3. Revisions to the Draft EIR

This chapter presents specific changes to the Draft EIR that were made in response to staff-directed changes including typographical corrections and clarifications. In each case, the revised page and location on the page is presented, followed by the textual, tabular, or graphical revision. Double Underline text represents language that has been added to the EIR; text with ~~strikethrough~~ has been deleted from the EIR.

Figure 4.13-5
Trip Distribution

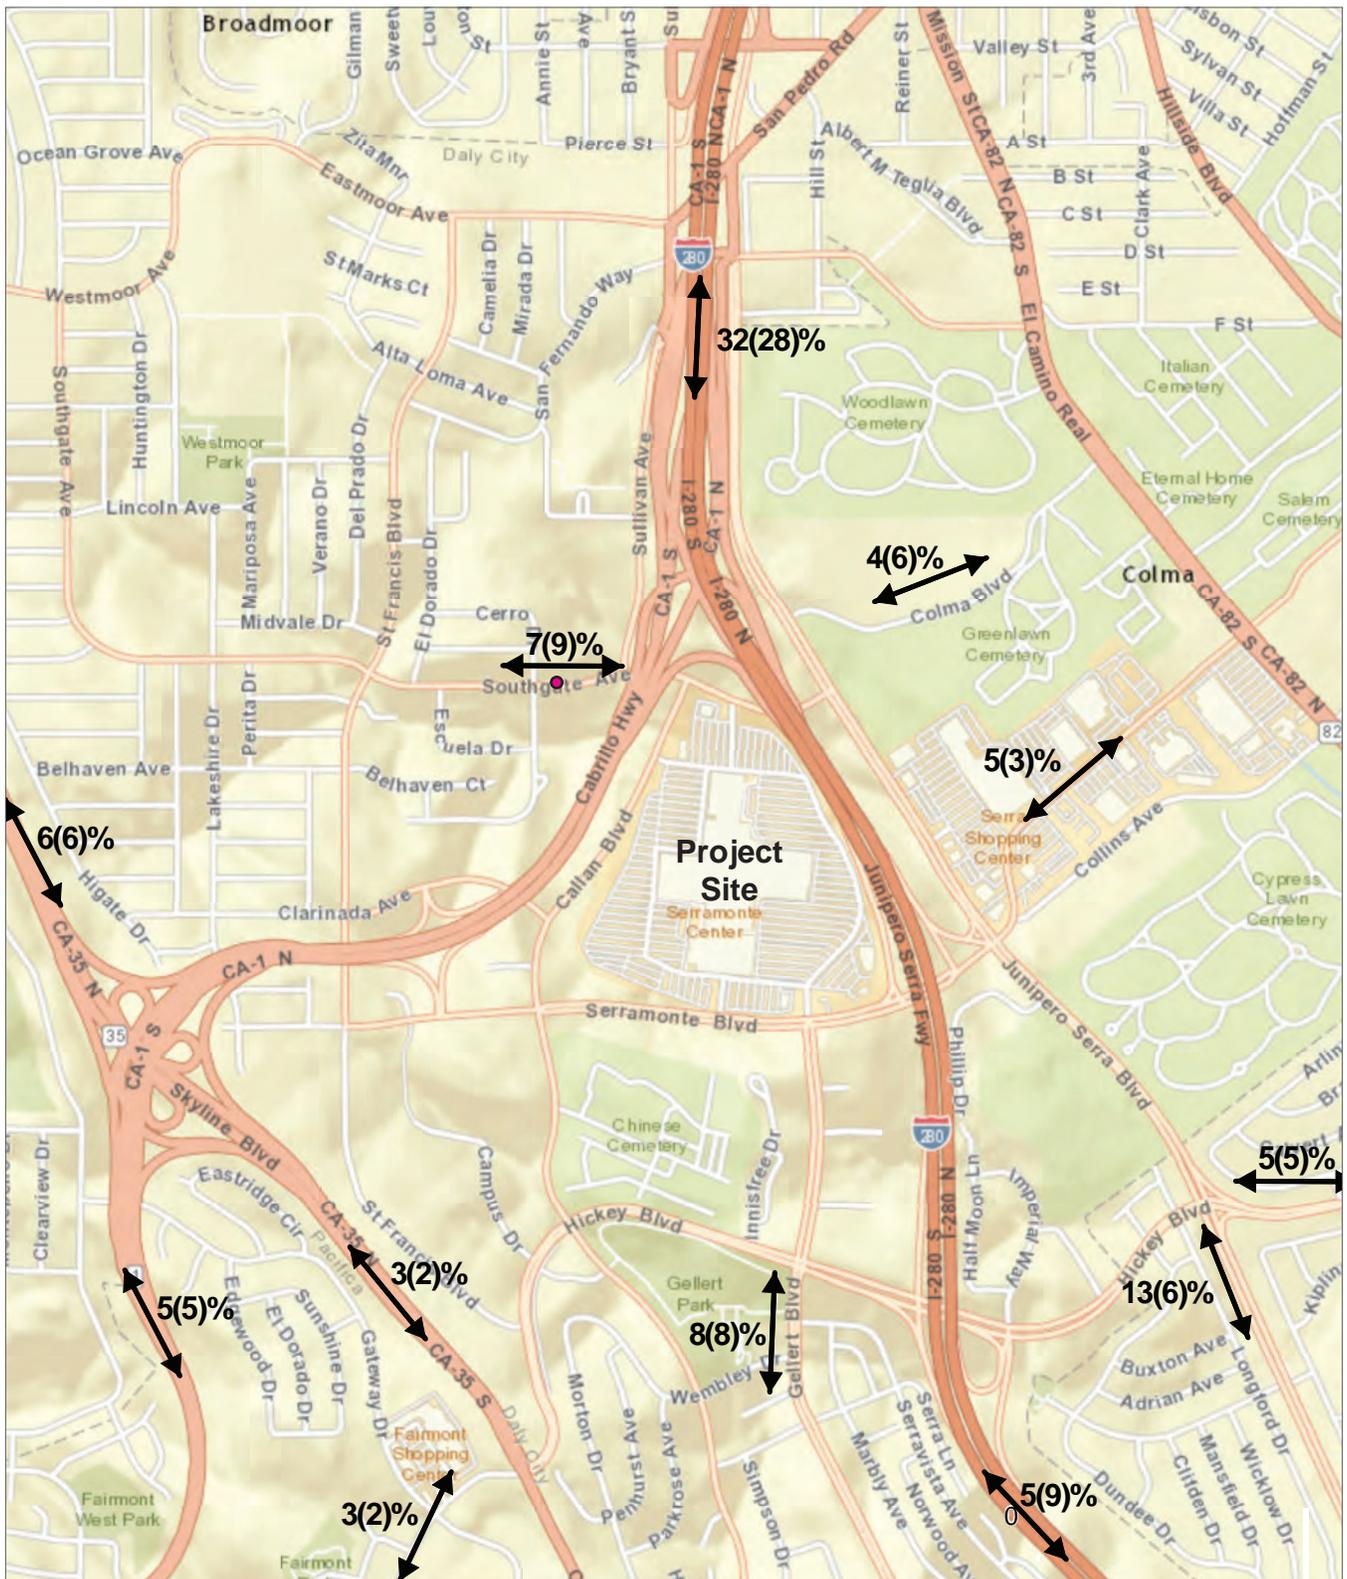
Figure 4.13-5, as shown on page 4.13-19 of the Draft EIR, has been revised to relocate the 5(3)% and arrow adjacent to Serramonte Boulevard, as shown on the following page (Comment A02-11).
